CHANGE/ERRATA INFORMATION

ISSUE NO: 3

Title: 9000A-Z80 Interface Pod
Print Date: June 1981
Rev. and Date: ---

Rev.-D, E, A12 280 Interface PCB Assembly (9000A-280-4072T)

Figure 1.

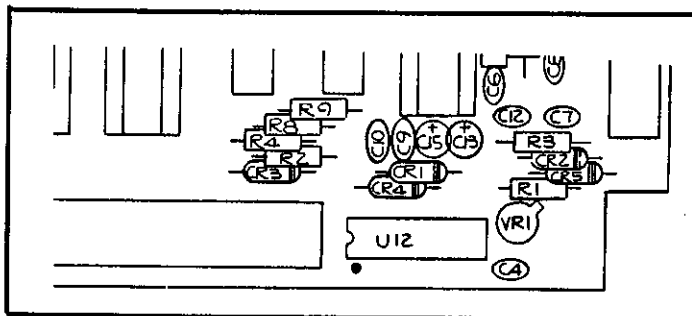
On page 6-11/6-12, Figure 6-3, make the additions listed above to the A12 reference designator drawing as shown in Figure 1.

ADD: C13|CAP, TA, 10 UF +/-20%, 15V
 |193623|56289|196D106X0015A1|REF

C15|CAP, TA, 10 UF +/-20%, 15V
 |193623|56289|196D106X0015A1|REF

ADD: CR6|DIODE, SI, HI-SPEED SWITCHING|313247|28480|HP5082-6264|1

ADD: R8|RES, DEP. CAR, 820 +/-5%, 1/4W
 |442327|80031|CR251-4-5P820E|1

R9|RES, DEP. CAR, 3K +/-5%, 1/4W|441527|80031|CR251-4-5P3K|1

ADD: XU2, XU4, XU6, XU8 and XU9|SOCKET, IC, 20-PIN
 |454421|01295|C932002|REF

Figure 2.

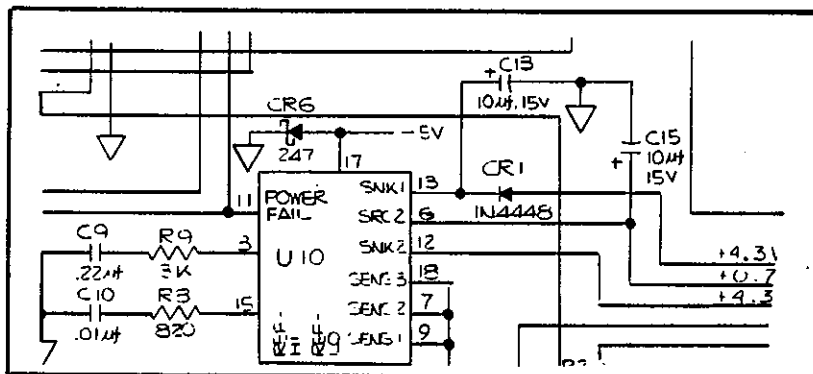
On pages 7-4 and 7-5/7-6, Figure 7-2, change the A12 schematic drawing as shown in Figure 2, and change the value of R4,

FROM: 12k

TO: 1.2k

Figure 3.

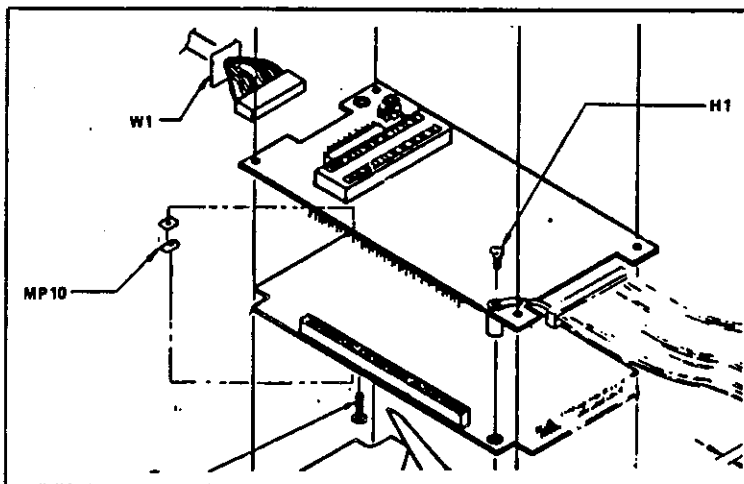
On page 6-4, Figure 6-1, add H1 and MP10 as shown in Figure 3.

On page 6-4, Figure 6-1, change W1 as shown in Figure 3.

ADD: MP9|9000A POD ACCESSORIES|613885|89536|613885|1
 -CABLE, UUT
 -LABEL, UUT CAUTION
 -PLASTIC BAG
 -SOCKET, DIP 40-PIN

ADD: MP10|RETAINING CLIP|583260|89536|583260|1

On page 6-3, Table 6-1, change the FLUKE STOCK NO. for W1,

FROM: 581827

TO: 581819
